**From:** Alannah Slattery <Alannah.Slattery@trca.ca>  
**Sent:** February 10, 2023 3:38 PM  
**To:** David (Transportation) Hunter  
**Cc:** Sharon Lingertat; Maryam Iler  
**Subject:** City of Toronto - Broadview Avenue EA - High Level TRCA Comments

TRCA received the draft Environmental Summary Report (ESR) for the Broadview Avenue Environmental Assessment, on January 18, 2023. The City has advised that they are planning on filing the final ESR for public review within the next couple of weeks. As this is the first time materials have been provided to TRCA for review, due to time constraints, TRCA staff have not completed a comprehensive, technical review of the draft ESR. In place of a formal review, a meeting was held between the City of Toronto and TRCA staff on February 7, 2023 to discuss the project and provide feedback. Based on this meeting, TRCA staff provide the following preliminary, high-level comments. It should be noted that these comments are not comprehensive and that a formal review and response will be provided once the final ESR is available.

Re: Broadview Avenue Extension Environmental Assessment

Subject: TAC Meeting #2A – Broadview Avenue Design Options Foc

# Segment #2: Broadview Intersection

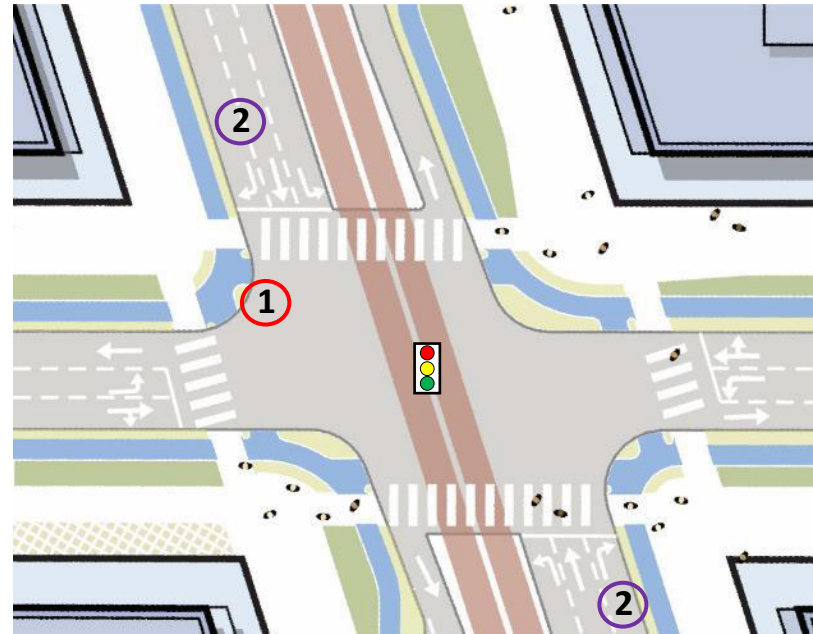
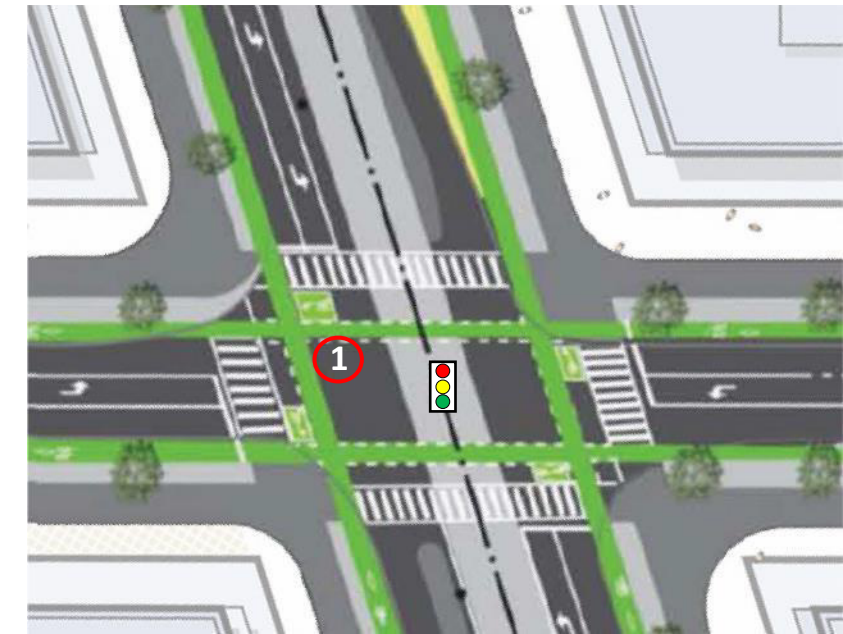
- ① CF version integrates Dutch-style protected **bike turning boxes** on curbs rather than on-street bike boxes in front of car traffic
  - This version is regarded as safer for cyclists, as it clears cyclists out of the intersection and avoids conflict with vehicles
- ② CF version includes **right turning lanes** along Broadview onto Street E

# Segment #3: Broadview to Booth

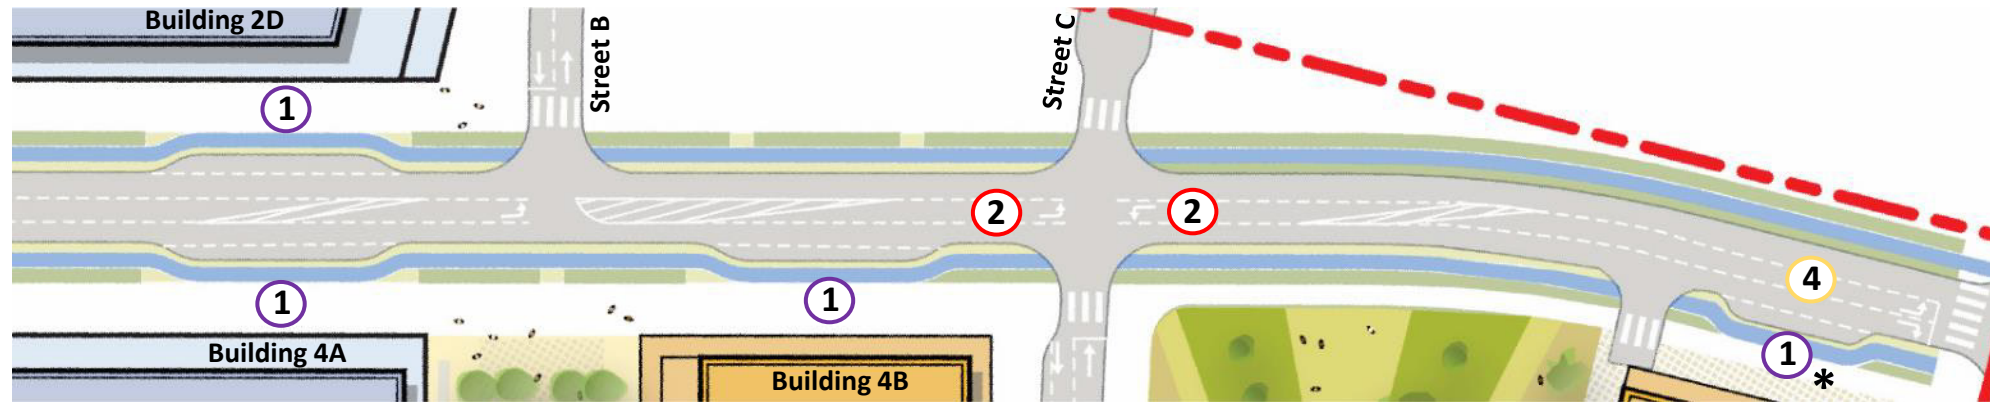
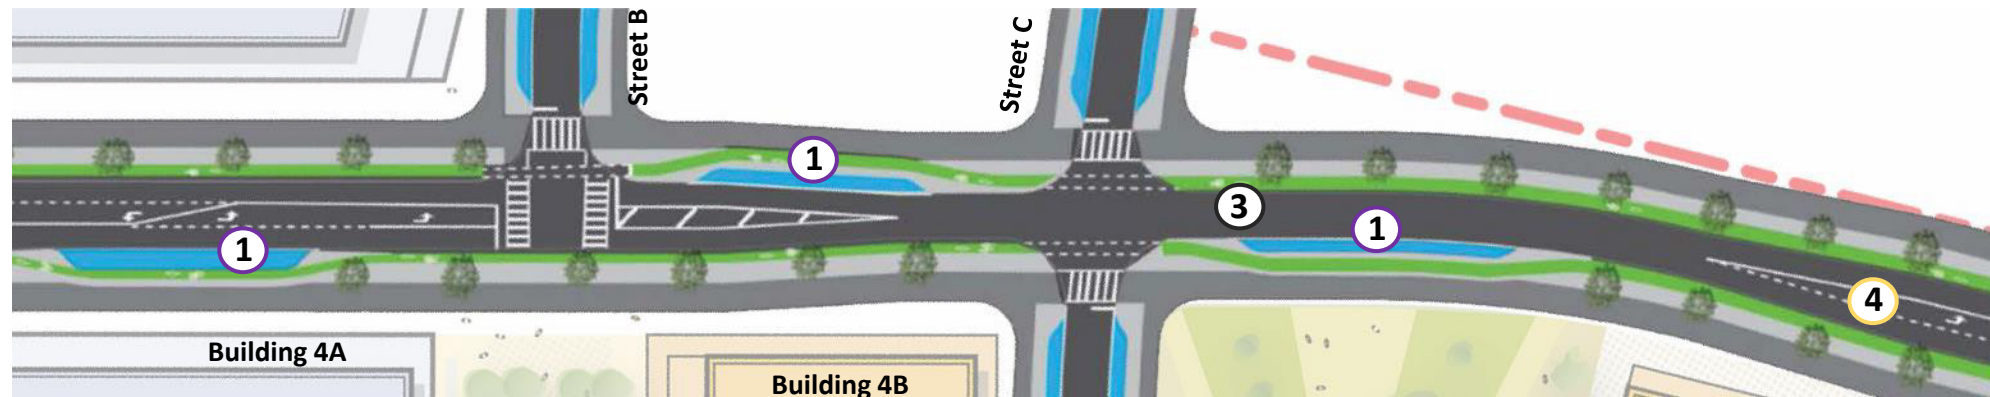
- ① CF version locates **laybys** at building frontages/entrances to support pick-up and drop off activities
  - Laybys at Buildings 2D and 4A are most critical
  - Potential to shift eastern layby further east
- ② CF version includes **left turning lanes** at Street C
  - Not critical for CF, but recommend protecting for left turn lane in future
- ③ City version **tapers** the ROW to 24m in some areas, while CF's version is consistently 27m
- ④ Adjustment to eastbound left turn **queuing lane** onto Booth can be accommodated

## CF Version with Layby

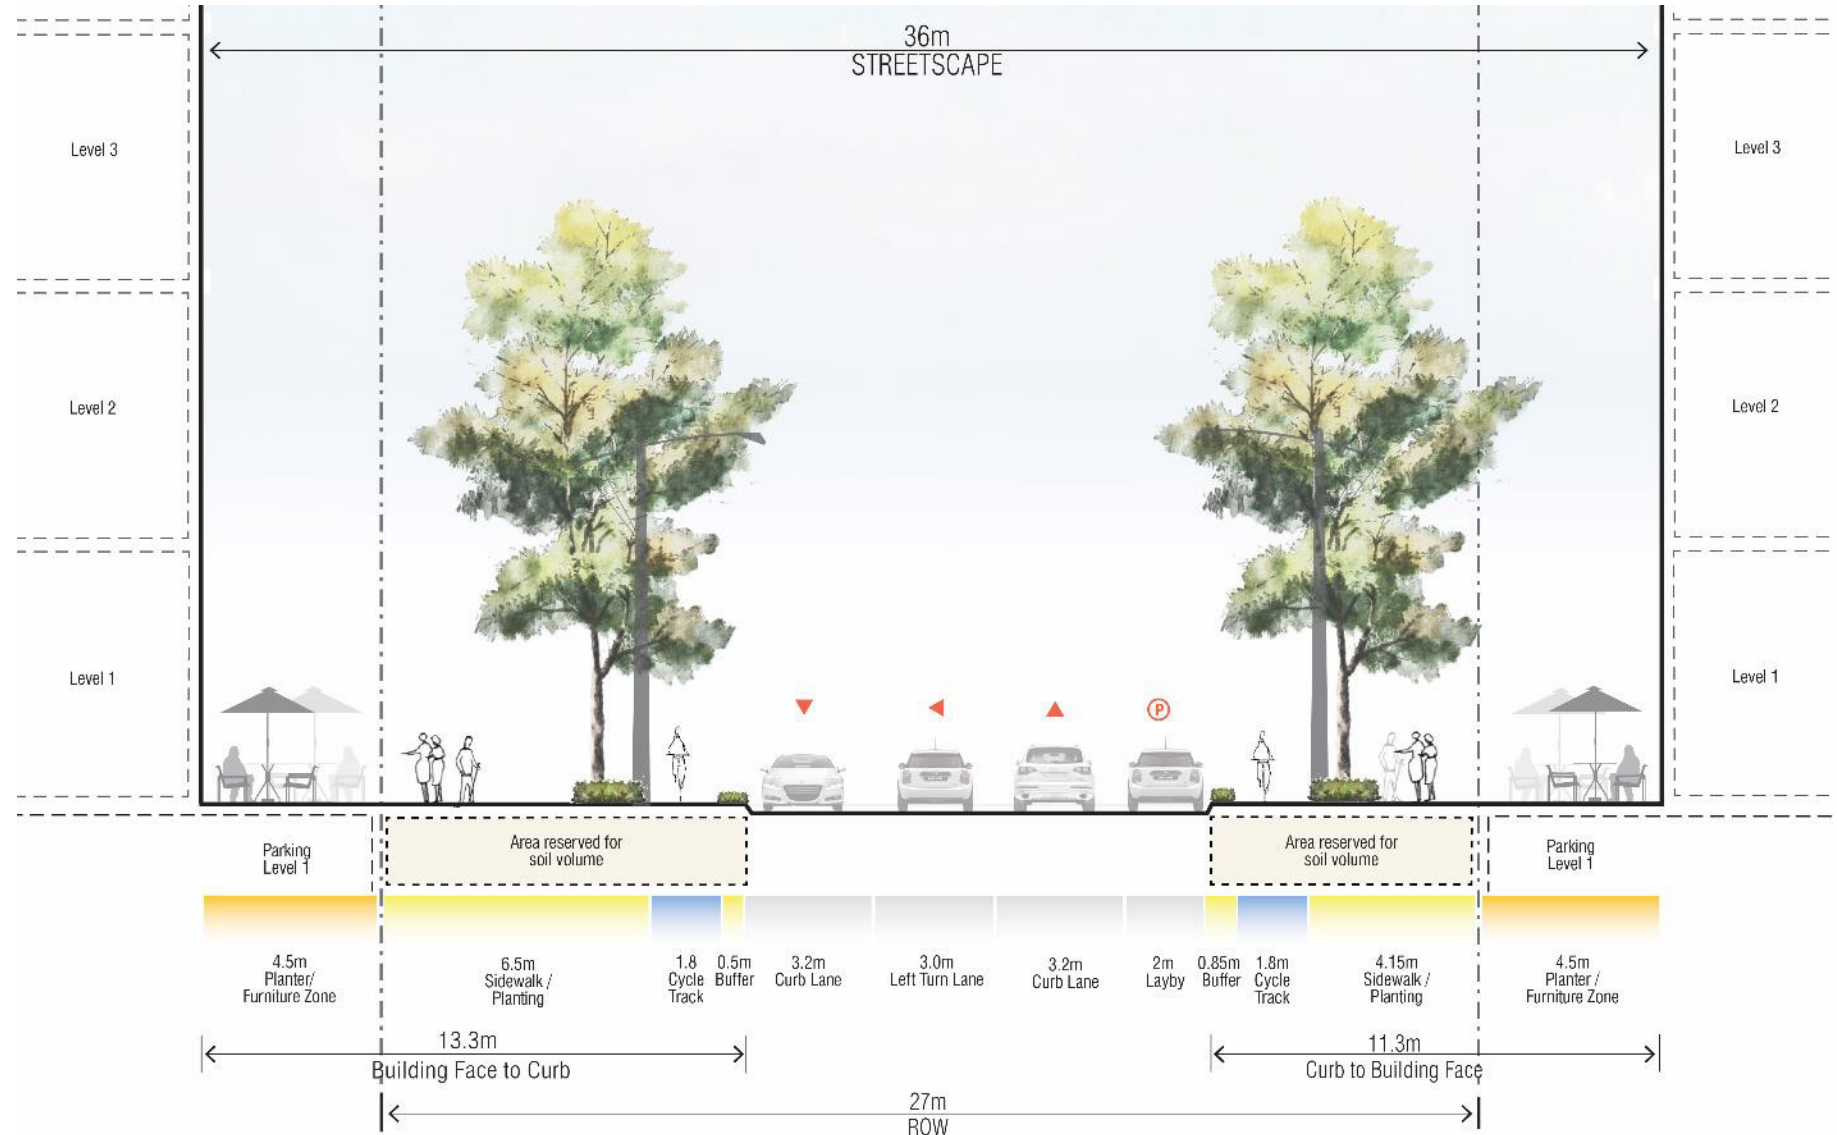
- 2.5m **layby** to accommodate film production trucks vs 2.0m shown in the City version

## CF Version without Layby

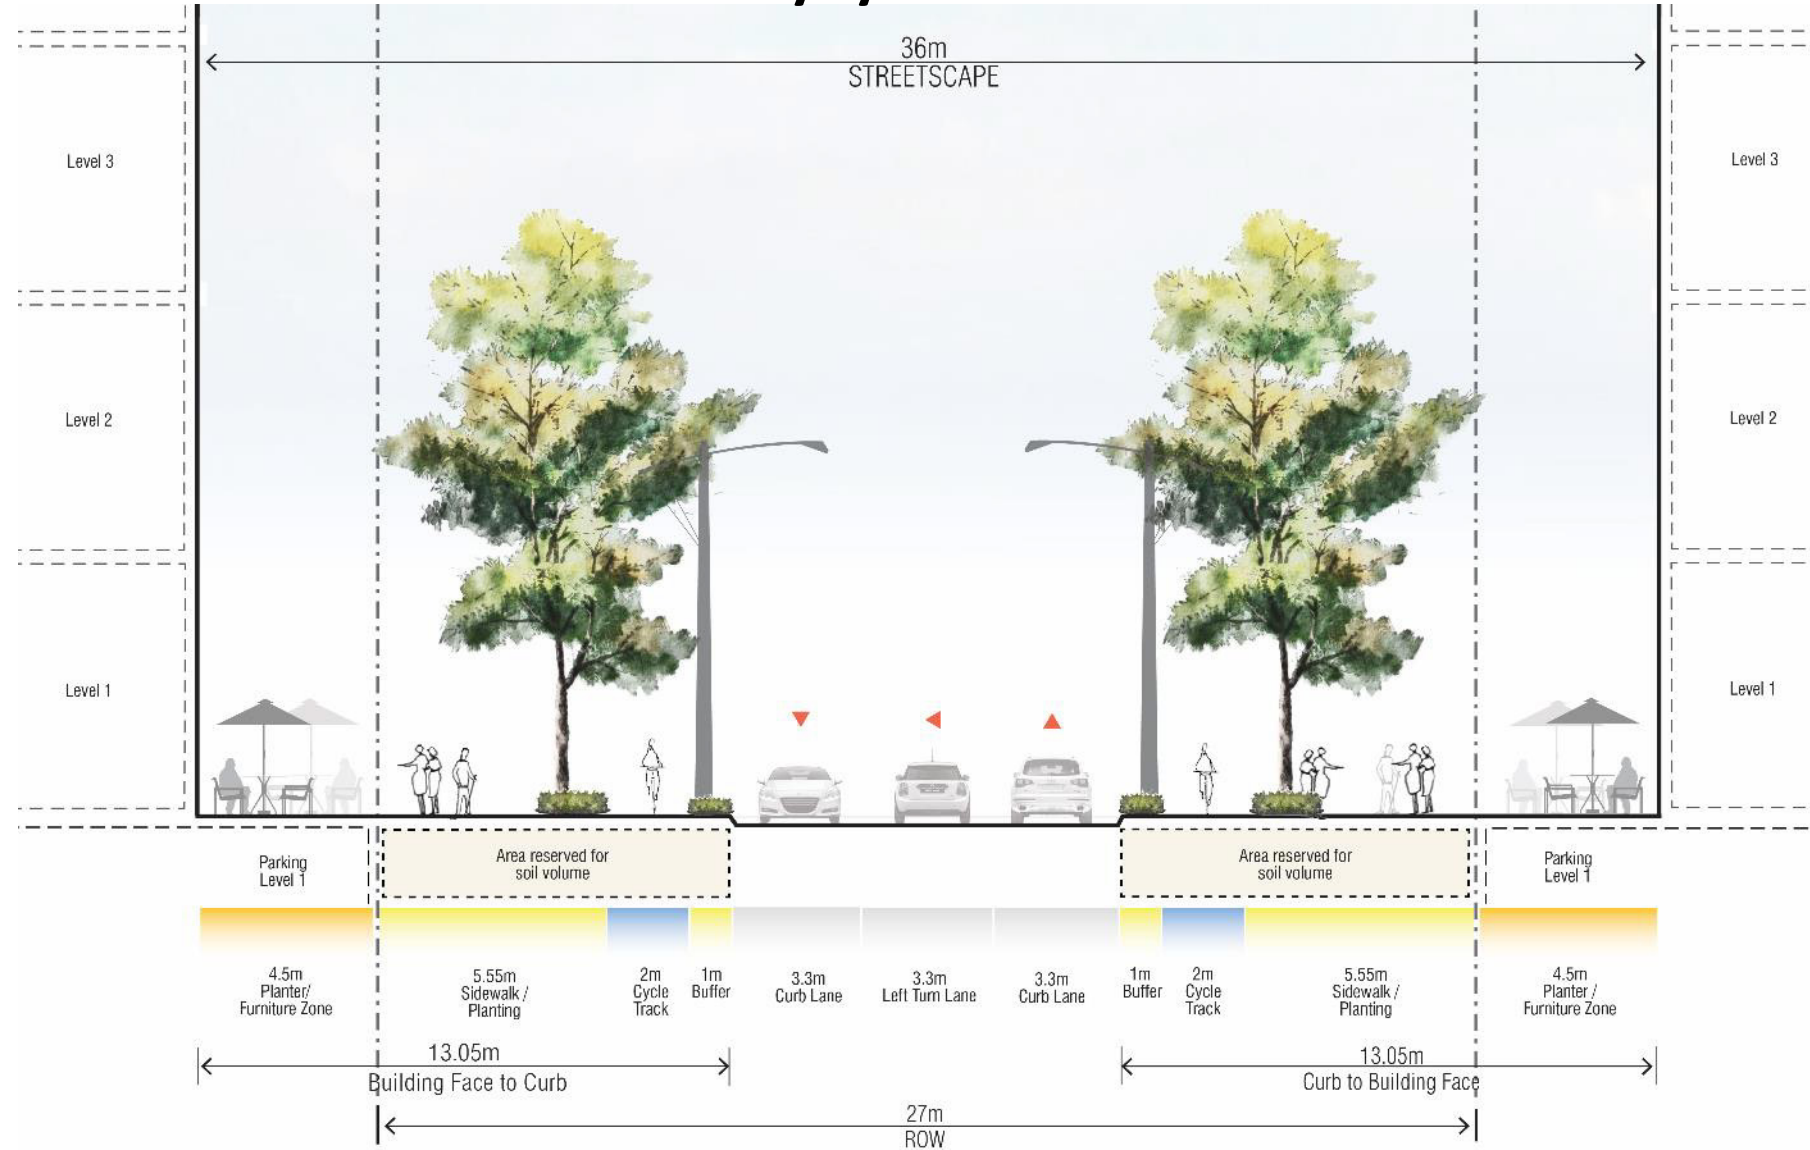
- 3.3m **driving lanes** vs the City's 3.2m
- 3.3m **turning lanes** vs the City's 3.0m

# Cross-Section without Laybys

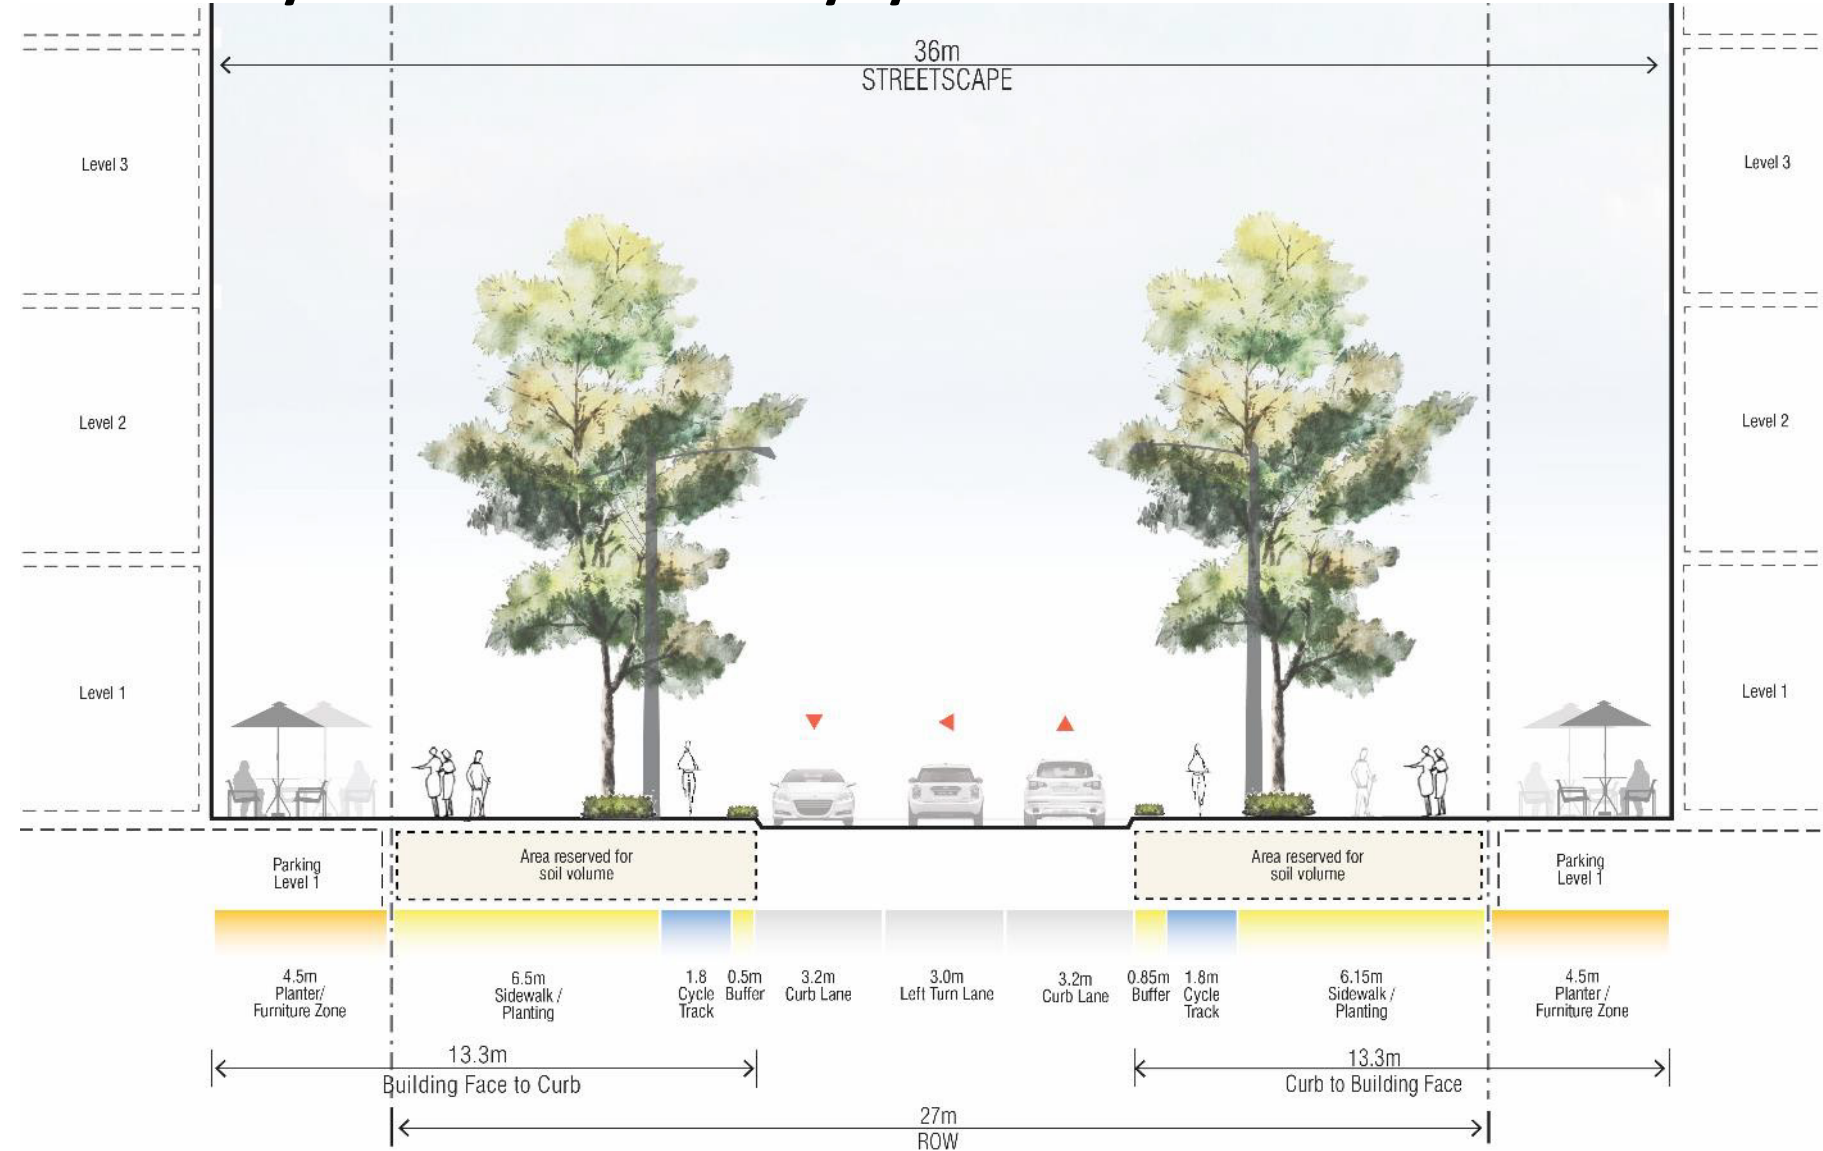
- 3.3m **driving lanes** vs the City's 3.2m
- 3.3m **turning lanes** vs the City's 3.0m
